HISTORIC AND DESIGN REVIEW COMMISSION

HDRC CASE NO: 2015-402
ADDRESS: 510 ADAMS ST
LEGAL DESCRIPTION: NCB 2914 BLK 3 LOT 3
ZONING: RM4 H
CITY COUNCIL DIST.: 1
DISTRICT: King William Historic District
APPLICANT: Juan Barrera
OWNER: Juan Barrera
TYPE OF WORK: Final approval of porch demolition and reconstruction
REQUEST:

The applicant is requesting a Certificate of Appropriateness for approval to demolish the existing concrete front porch and construct a new, wood front porch.

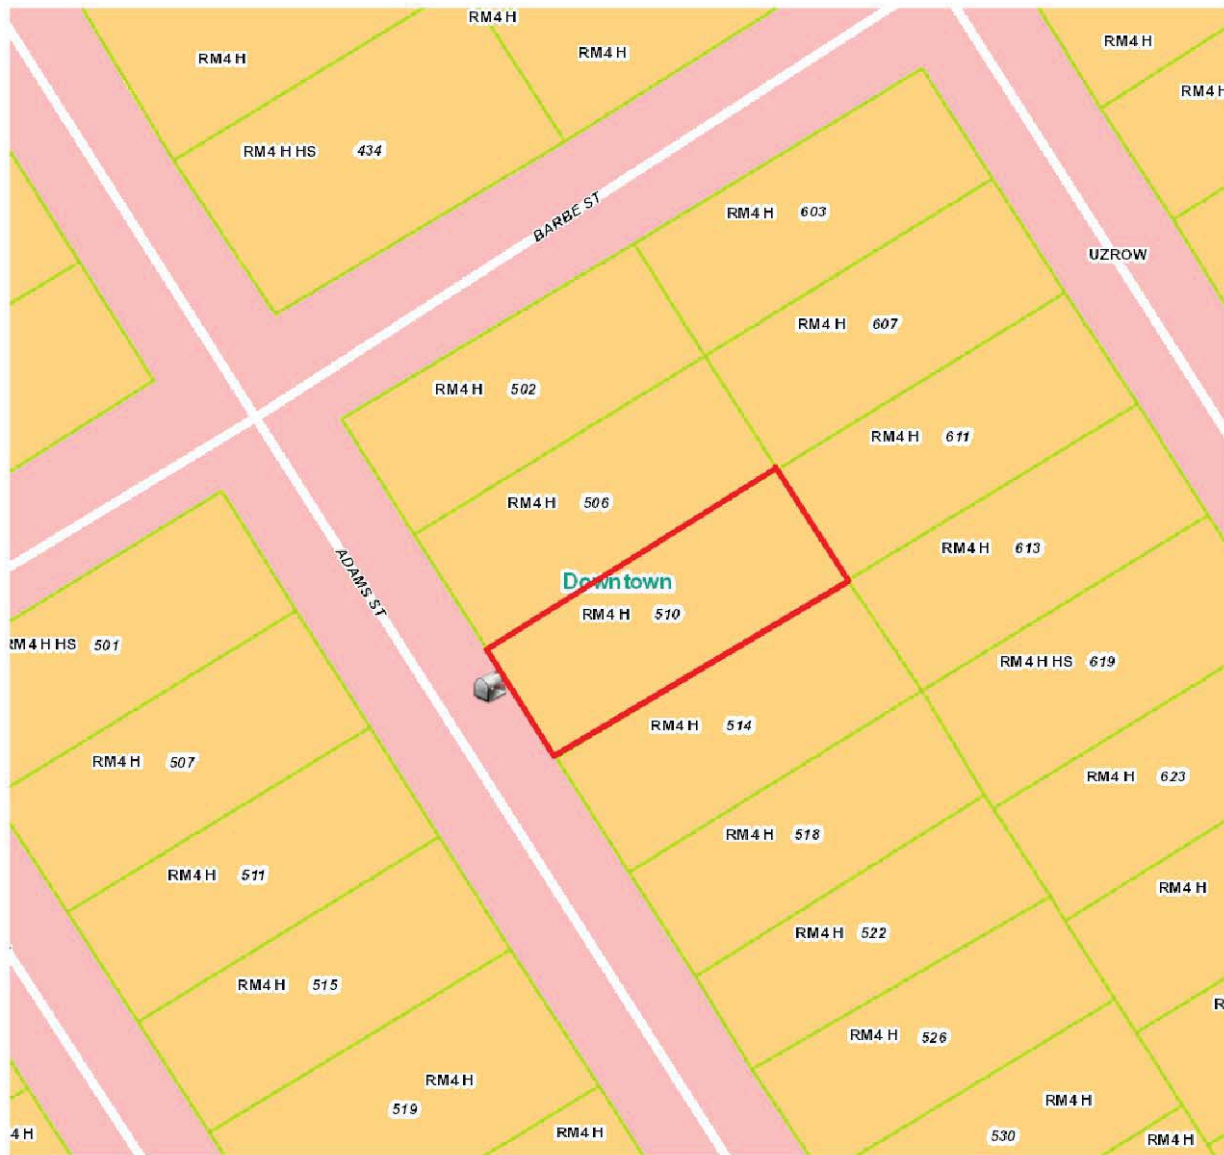
- a. The house at 510 Adams is of the Craftsman style and was constructed circa 1930. Craftsman style homes commonly feature both concrete and wood front porches as well as a combination of the two. The applicant has proposed to remove the existing, damaged concrete porch and construct a new, wood porch to feature dimensions to match the existing.
- b. According to the Guidelines for Exterior Maintenance and Alterations 7.B.iv., the design of porch reconstruction should be compatible in scale, massing and detail as the original. The applicant has proposed to retain the existing

porch height and width to be consistent with the Guidelines. While the applicant has proposed a material change, staff finds this material change architecturally appropriate.

- c. The applicant has proposed to construct front porch railing on both the south and east porch facades. According to the Guidelines for Exterior Maintenance and Alterations 7.B.iv., added elements should be added as to not distract from the historic character of the building. The proposed railing is simple in design featuring square railings and post caps and will be painted to match the other porch wood. This is consistent with the Guidelines.

Staff recommends approval as submitted based on findings a through c.
